# UNITED STATES PATENT AND TRADEMARK OFFICE

10/749,822

<b>Office Action Summary</b>	<b>Application No.</b> 10/749,822	<b>Applicant(s)</b> PAFFORD ET AL.	
	<b>Examiner</b> MARY HOFFMAN	<b>Art Unit</b> 3733

## DETAILED ACTION

Schlapfer et al. (Patent 5,501,684)

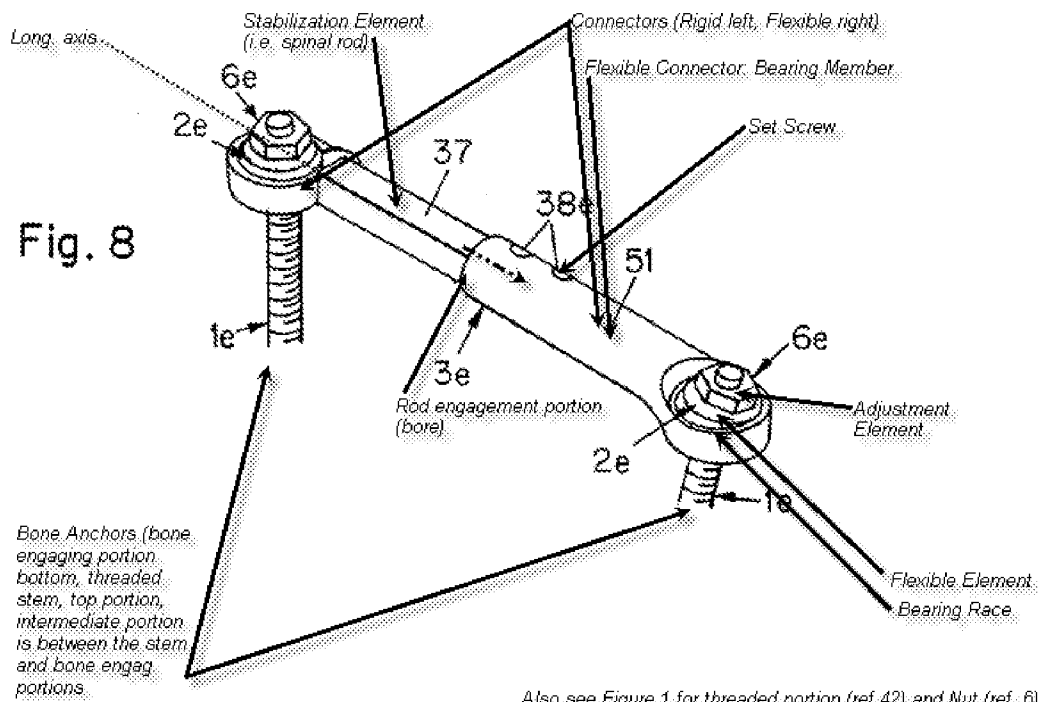
Schlapfer et al. disclose a dynamic stabilization system for stabilization comprising a stabilization element (FIG. 8, ref. 37) capable of spanning between at least two vertebrae and defining a longitudinal axis along the length of the element: at least two bone anchors (ref. 1e), each having a bone engagement portion (lower half); and at least two connectors (see FIG. 8, attachment mechanisms fixing ref. 1e to the stabilization element, ref. 37) for connecting a corresponding one of the bone anchors to the stabilization element, at least one connector including; a bearing member (ref. 51) attached to the stabilization element; a compressible flexible element (ref. 2e) supported within the bearing member with the bone anchor extending through the flexible element, the flexible element contacting the bearing member substantially along the longitudinal axis of the stabilization element to permit relative pivoting between the corresponding bone anchor and the stabilization element and the flexible element is configured to expand along the longitudinal axis as the element is compressed; and an adjustment

element (ref. 6e) configured to compress the flexible element to thereby adjust the flexibility of the flexible element to adjust the amount of the relative pivoting (claim 1).

The stabilization element includes an elongated spinal rod, the bearing member is a rod end bearing including a rod engagement portion; and the flexible element is a bearing element of the rod end bearing (claim 3). The bearing element is received within a bearing race (integral with ref. 51, the surface along circumference of the bore in which ref. 2e is placed) of the rod end bearing; and the adjustment element is arranged to compress the bearing element within the bearing race (claim 4). The rod engagement portion includes a bore for receiving a portion of the spinal rod therein and a set screw (ref. 38e) for clamping the spinal rod within the bore (claim 5). The at least one of the bone anchors includes a stem having a threaded portion (see FIG. 1, ref. #42); the flexible element includes a bore for receiving the stem therethrough; and the adjustment element includes a nut engaging the threaded portion and arranged to compress the flexible element as the nut is threaded onto the threaded portion (claim 6). The at least one of the bone anchors includes an intermediate portion (see FIG. 1, ref. 11) between the stem and the bone engagement portion, the intermediate portion configured to support the flexible element so that the flexible element is compressed between the intermediate portion and the nut when the nut is threaded onto the threaded portion (claim 7). Another of the connectors is configured to substantially rigidly connect one of the bone anchors to the stabilization element (see FIG. 8, left side) (claim 8). The flexible element has a substantially spherical outer surface; and the bearing race defines a substantially spherical inner surface engaging the outer surface of the flexible

element (claim 31). The flexible element is compressible along an axis substantially perpendicular to the longitudinal axis; and the adjustment element is configured to operate along the substantially perpendicular axis (claim 32).
